MITIGATED NEGATIVE DECLARATION

THE CITY OF SAN DIEGO

Project No. 522075

SUBJECT: **HILLCREST 111: NEIGHBORHOOD DEVELOPMENT PERMIT (NDP)** to demolish the existing surface parking lot and to allow the development of 111 residential dwelling units, including nine very-low income units, and 4,800 square feet of commercial retail space within a ~~136,213~~136,816-square-foot, seven story mixed-use building with three levels of underground parking and a detached subterranean parking structure, all located on a 42,000 square-foot site at 635 Robinson Avenue (APN 452-103-61-00) in the Uptown Community Plan area. The project would comply with existing Conditional Use Permit (CUP) No. 11086 and would continue to provide parking (86 stalls) for the AT&T building located off-site and immediately north of the project site. The project site is zoned MR-800B (Residential-High Density) and CN-1A (Mixed-Use-Very High Intensity) within the Mid-City Communities Planned District. It is also subject to the Airport Influence Area (Review Area 2), Federal Aviation Administration (FAA) Part 77 Noticing Area for the San Diego International Airport; Residential Tandem Parking Overlay Zone; and the Trans

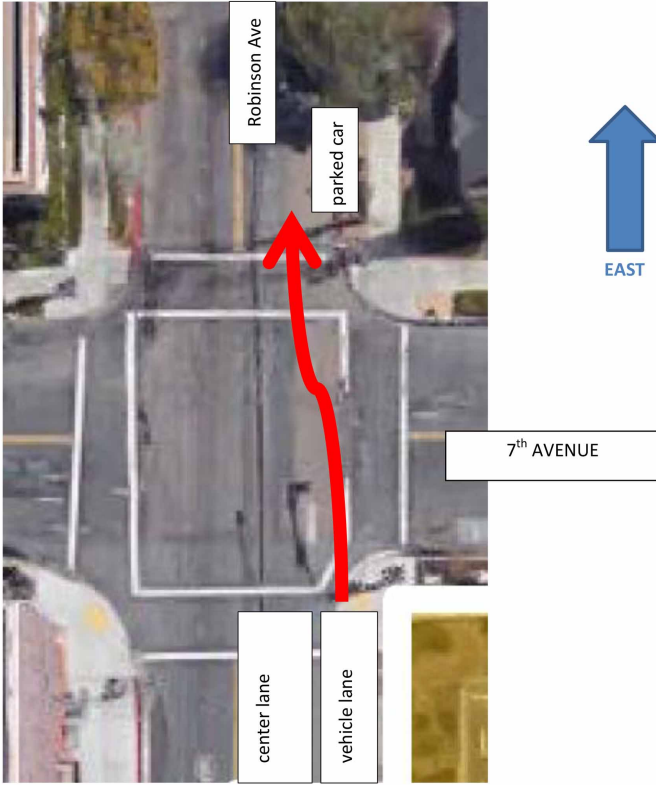
COMMENT	RESPONSE
<p>C-4 c. The MND proposes the striping of a center lane on Robinson in <u>both directions</u>. Such a lane is not feasible going <u>westbound</u>. Robinson, at 40 ft wide, is too narrow to include two travel lanes, a parking lanes, and a center lane. The mitigation should include removal of parking on the south side of Robinson, east side of 7th Ave.</p> <p>3. Intersection of the alley and Robinson.</p> <p>C-5 a. Corner visibility. See attached photo. When exiting the alley onto Robinson, there are two group of poles to the west, which seriously impede visibility. The poles should be relocated or eliminate by undergrounding.</p> <p>C-6 b. Turning room. The attached photo illustrates the difficulty of turning from a narrow street, Robinson, into a narrow alley, 20 ft wide. A solution would be widening the alley, and removal of the utility poles. These solutions must be done at the time of the project, when they are feasible.</p> <p>C-7 c. Width of garage entrance. This appears to be inadequate to accommodate all traffic to the 111 housing units and the commercial spaces (including delivery and customers).</p> <p>4. Solutions. The following changes would avoid the adverse conditions:</p> <p>a. A scaled-down project which would result in less traffic.</p> <p>b. Widening Robinson by moving the curb southward. This would facilitate a viable center turn lane onto 7th Ave. It would allow turning room for traffic entering and exiting the alley. It would also allow a future bike lane.</p> <p>C-8 c. A larger setback of the building from the lot line on Robinson, to improve corner visibility for alley traffic and 7th Ave traffic.</p> <p>d. Widening the alley to allow vehicles feasible access from Robinson Ave, and from the parking garage.</p> <p>e. Relocating or removing power poles.</p> <p>f. Removing parking spaces where needed to allow safe traffic movement.</p> <p>Tom Mullaney Uptown United</p> <p>Attachments: Three photos.</p>	<p>C-4 The Traffic Assessment (Appendix I to the MND) includes a sketch of the proposed striping. It shows extension of the left turn bays provided at 6th Avenue and 7th Avenue to create a continuous left turn lane. This will provide turn access into the alley. It also shows adding a left turn bay for westbound movement, to match the existing turn bay for the eastbound movement, forming a consistent center turn lane from east of 7th Avenue to west of 6th Avenue. This improvement would remove parking on Robinson Avenue, between 6th Avenue and 7th Avenue, resulting in the loss of three two-hour parking stalls on the south side of Robinson Avenue and two two-hour parking stalls on the north side of Robinson Avenue. The three spaces on the south side of Robinson Avenue would also be required to be eliminated to allow for fire accessibility. A commercial loading zone would also be removed on the north side of Robinson Avenue and relocated to 7th Avenue north of Robinson Avenue. This also requires the elimination of two parking meters.</p> <p>C-5 The proposed project would underground overhead utilities (high and low voltage) along the south side of Robinson Avenue, from 6th Avenue to 7th Avenue. The project would also remove and rehang utilities along the alleyway – removing poles along the east side of the alleyway and hanging those overhead utilities off the existing poles that will remain in place along the west side. The commenter’s photo suggests that there is adequate sight distance to the west for drivers exiting the alley.</p> <p>C-6 The alleyway is 20 feet wide and built to City width standards.</p> <p>C-7 The garage entrance has been designed to Land Development Code standards. The driveway width accessing the garage is 24 feet.</p> <p>C-8 a. Comment noted. As analyzed in the MND, the project would result in a significant traffic impact on a segment of Robinson Avenue between 6th Avenue and 7th Avenue. That impact would</p>

COMMENT	RESPONSE
	<p>be mitigated to below a level of significance by restriping the impacted segment of Robinson Avenue, providing a separate left turn lane at the eastbound and westbound approaches at Robinson Avenue and 7th Avenue, and the associated traffic signal modifications.</p> <p>b. The project's mitigation for significant traffic impacts includes the removal of on-street parking between 6th Avenue and 7th Avenue. This provides sufficient width for two through lanes and a center left turn lane. No additional widening is needed to provide this cross section. In addition, widening on the south side would create an offset of the eastbound travel lane across the 7th Avenue intersection.</p> <p>c. The project meets sight distance requirements.</p> <p>d. As previously noted, the alleyway is built to City width standards, and the project does not propose to widen the alley.</p> <p>e. Relative to relocating or removing power poles, the proposed project would underground overhead utilities (high and low voltage) along the south side of Robinson Avenue, from 6th Avenue to 7th Avenue. The project will also remove and rehang utilities along the alleyway – removing poles long the east side of the alleyway and hanging those overhead utilities off the existing poles that will remain in place along the west side.</p> <p>f. Relative to removal of on-street parking, parking spaces on the south side of Robinson Avenue adjacent to the project are being removed as part of the project, as are several on the north side of Robinson Avenue. Mitigation for traffic impacts would remove parking on Robinson Avenue, between 6th Avenue and 7th Avenue, 7th Avenue, resulting in the loss of three two-hour parking stalls on the south side of Robinson Avenue, two two-hour parking stalls on the north side of Robinson Avenue, and two to three parking stalls on the south side of Robinson</p>

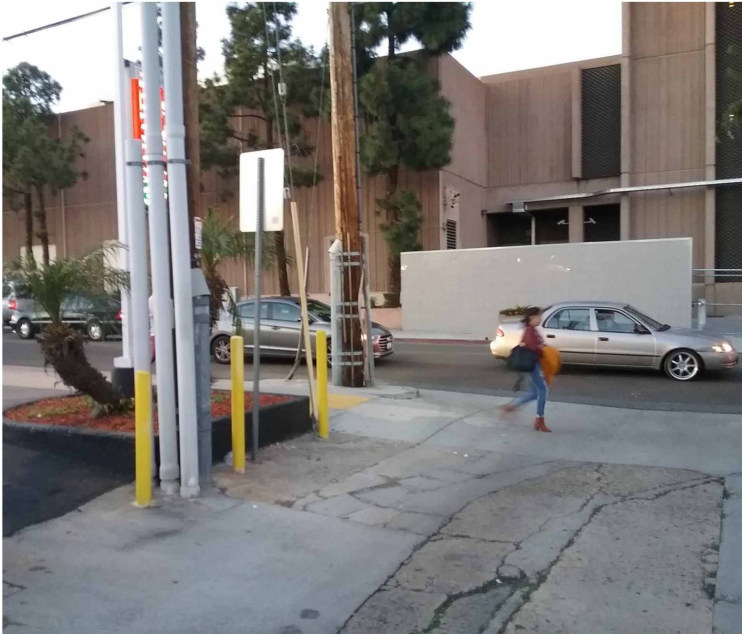
COMMENT	RESPONSE
<p>Intersection of Robinson Ave and 7th Ave. DANGER!</p> <p><u>Problem:</u> Striping a center turn lane on Robinson would force eastbound traffic to the side of the street. While passing through the intersection, vehicles would need to angle to the left, to avoid parked cars. Speed would have to be reduced. A driver focused on the intersection and crosswalks might not see the parked cars.</p> <p><u>Solution:</u> Remove parking spaces on Robinson, east of 7th Ave.</p>  <p>3</p>	<p>C-9 These pages are attachments to Comment Letter C.</p>
